Generator Technical Performance Standards (GTPS) Rule Change – Submission on behalf of WSP Australia Pty Ltd

Table 1 Summary of responses to rule change request

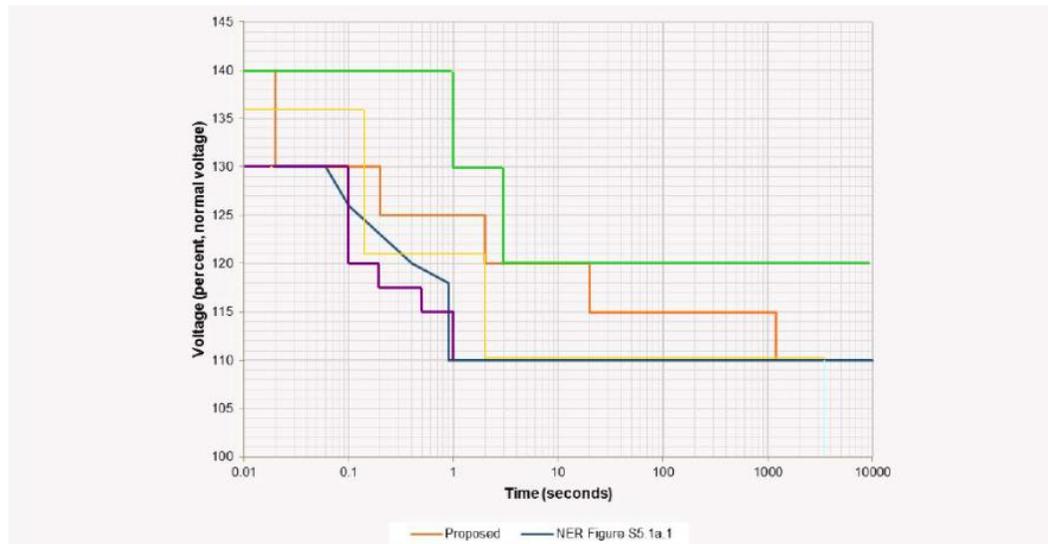
The events from the SA System Black event were due to extreme weather events and imposing requirements on applicants based on these extreme events could be viewed as too onerous. AEMO has provided some historical data from ElectraNet with regards to previous faults. Exposure to a large number of faults such as this is challenging both from a power system planning as well as operational perspective. Where this is within the capability of standard equipment, WSP see no issues with ensuring that the full capability of the generating units is documented. Care should be given however when planning power systems in order to minimise the impact of such events.

Exposing rotating machines such as synchronous generators or synchronous condensers to multiple faults within a short period places significant mechanical stress on generators and turbines. For example, it is not uncommon to limit the number of auto-reclose events in the vicinity of synchronous generators in order to reduce the mechanical stresses on generating units. Furthermore, there is also a risk of loss of synchronism due to multiple faults which should be considered in the rule change (related to disconnection under S5.2.5.10). This would apply not only to synchronous generating systems, but also asynchronous generating systems which comprise of synchronous units.

WSP suggest development of a mechanism to allow disconnection under S5.2.5.10 as part of the requirement to ride through multiple faults and where damage to plant or a reduction in the design life of the Generating System can be demonstrated.
